Proposal for the 07 series of amendments to Regulation No. 48 (Installation of lighting and light-signalling devices)

Note: The text reproduced below was prepared by the expert from Poland to improve the OICA and GTB proposal in ECE/TRANS/WP.29/GRE/2015/5 introducing new criteria on the automatic levelling of headlamps based on the GTB glare and visibility studies. The modifications to the proposed text are marked in blue bold for new Polish changes or orange strikethrough for deleted characters of the GTB-OICA proposal.

(Option 1)

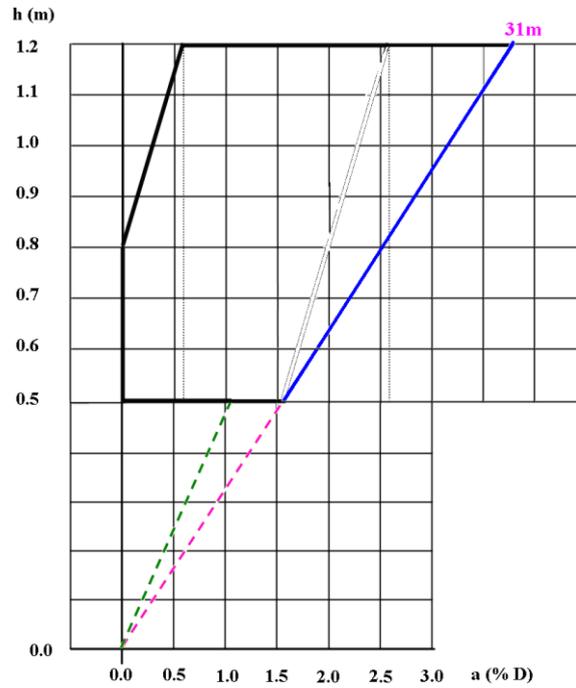
- h = 0.5 m: from 0.0 per cent to -1.6 per cent;
- h = 0.8 m: from 0.0 per cent to -2.0 per cent;
- h = 1.2 m: from -0.6 per cent to ~~-2.6~~ -3.8 per cent.

Comment [tt1]: To keep GTB proposed 31 m value of the road illumination distance.

(Option 2)

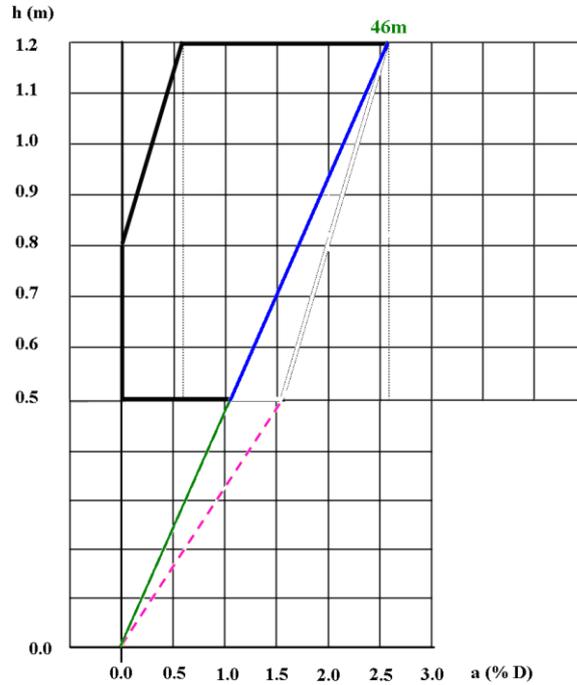
[h = 0.5 m: from 0.0 per cent to ~~1.6~~ 1.1 per cent;
h = 0.8 m: from 0.0 per cent to -2.0 per cent;
h = 1.2 m: from -0.6 per cent to -2.6 per cent]

Comment [tt2]: Or alternatively to keep GTB proposed 46 m value of the road illumination distance.
Any other minimum road illumination distance can be easily chosen.
Poland recommend 50 m.

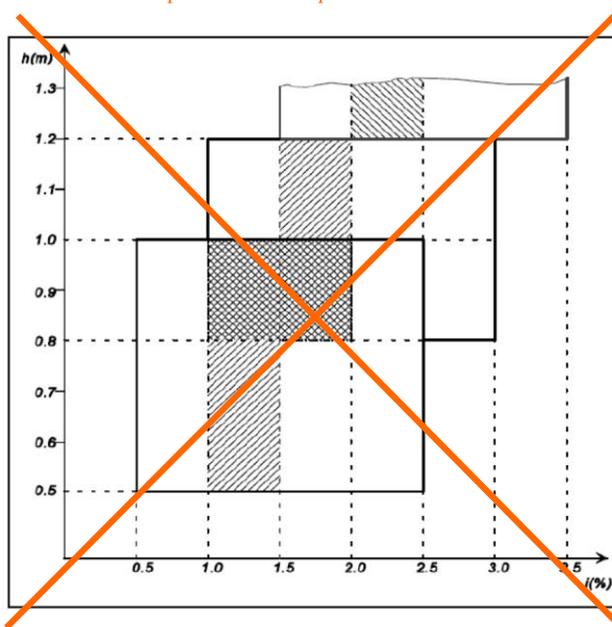
~~The above limits and the initial aiming values are summarised in the diagram below.~~
